**REQUEST FOR WAIVER FROM ACCESSIBILITY REQUIREMENTS  
OF CHAPTER 553, PART V, FLORIDA STATUTES**

**Name: Ocean Breeze Hotel, OWNER: RIST PROPERTIES, LLC**

**Address: 6600 Collins Avenue, Miami Beach, Florida 33141**

**1: Florida statutes 553.509 Vertical Accessibility to all levels requirement. / 2007 FBC 11-4.1.6(1)(f)**

**PROPOSED  
RAMP**

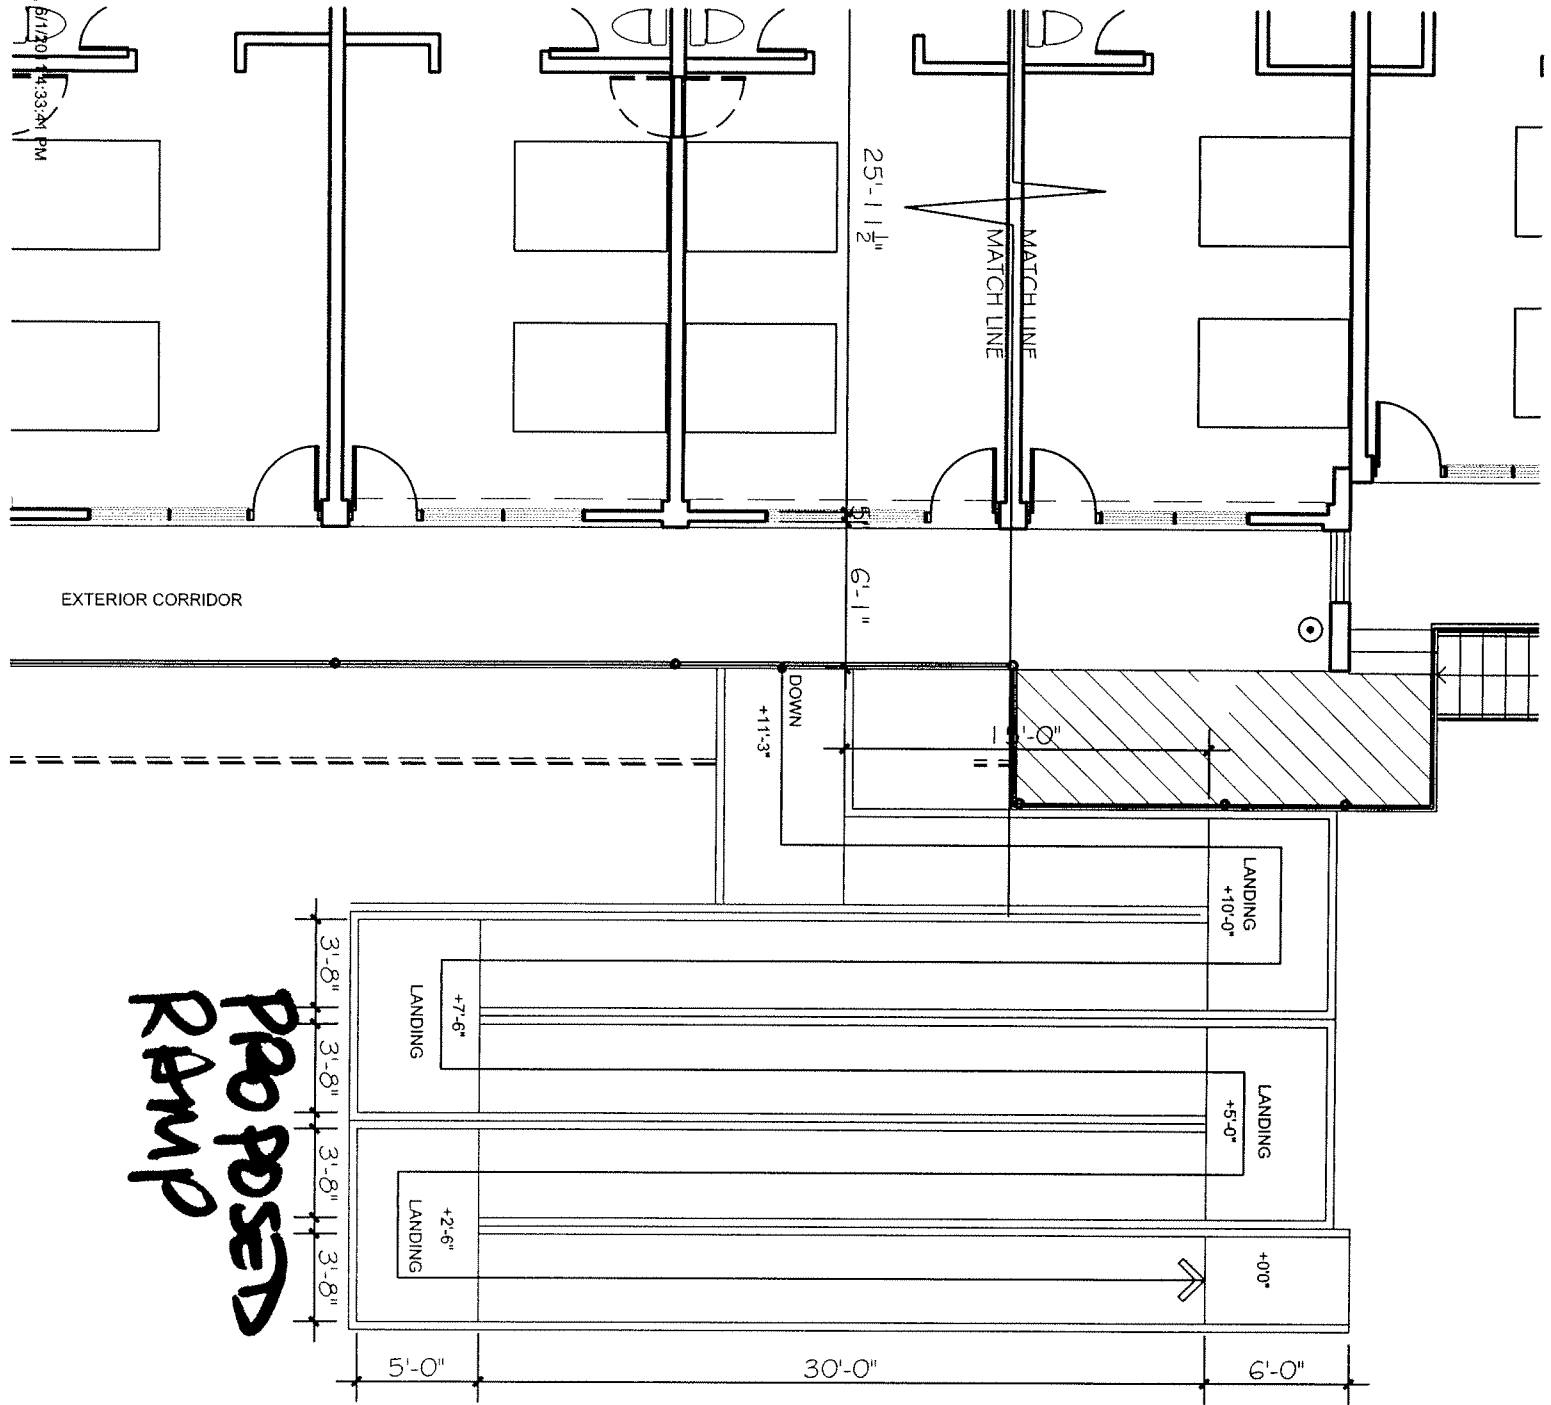
**Owner has explored the possibility of constructing a ramp to provide an accessible route. Planning and Zoning has indicated, that ramp as proposed, it would not be consistent with the existing structure and would be, visibly, a very heavy structure in front of the building detracting from its look, character and style.**
